ADDENDUM NO.   1   DATED   5/21/2013   ADDENDUM NO.            DATED             
 ADDENDUM NO.            DATED            ADDENDUM NO.            DATED

Number	Description
1	Table of Contents, replace same; NTB No. 4524 replaces NTB 3242; Add NTB Nos. 4532, 4533, 4534 & 4535; Supplements to 907-401-2 & 907-403-4, replace same; BidItems, replace same; Added or Revised Plan Sht. Nos. 2, 22, 23, 214, 2001, 2002, 2003, & 2004; Amendment EBS Download Required.

# MISSISSIPPI DEPARTMENT OF TRANSPORTATION

### PROJECT: STP-7337-00(001) / 103408301 – Rankin County

DETAIL OF DRUM PLACEMENT AT PAVEMENT EDGE DROP-OFF

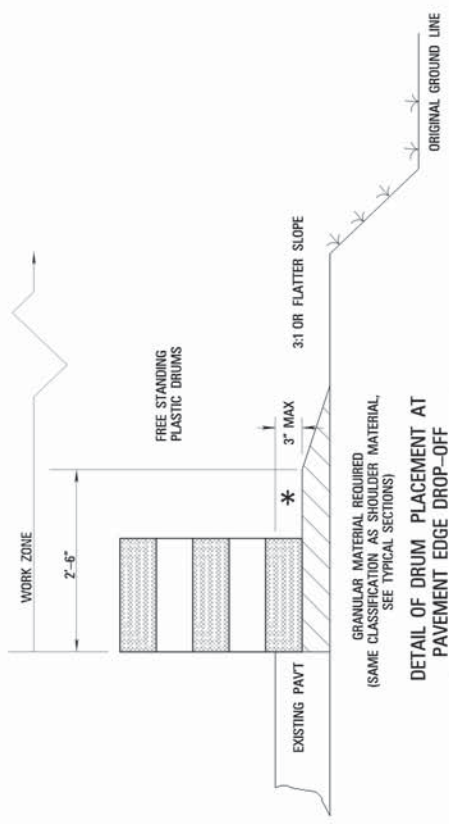
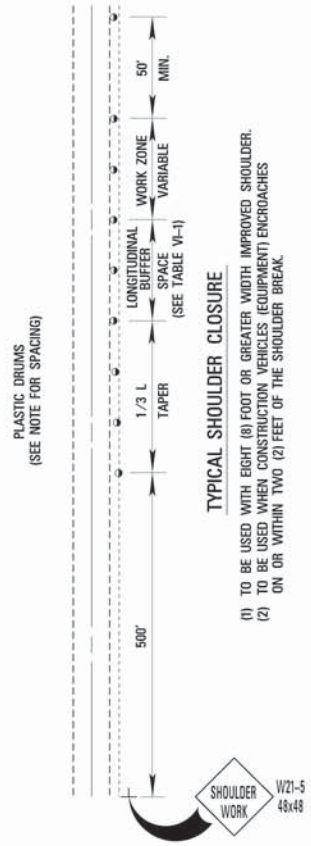
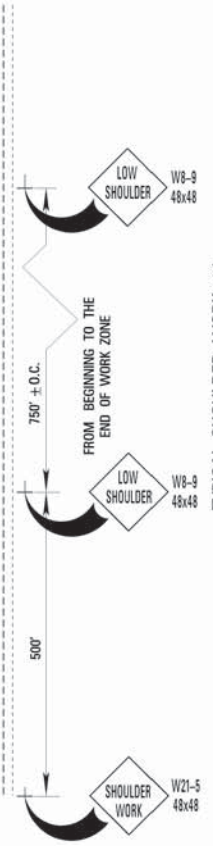
Bidders are hereby advised that the attached detail was inadvertently omitted and is hereby added to and made part of the plans and contract documents.
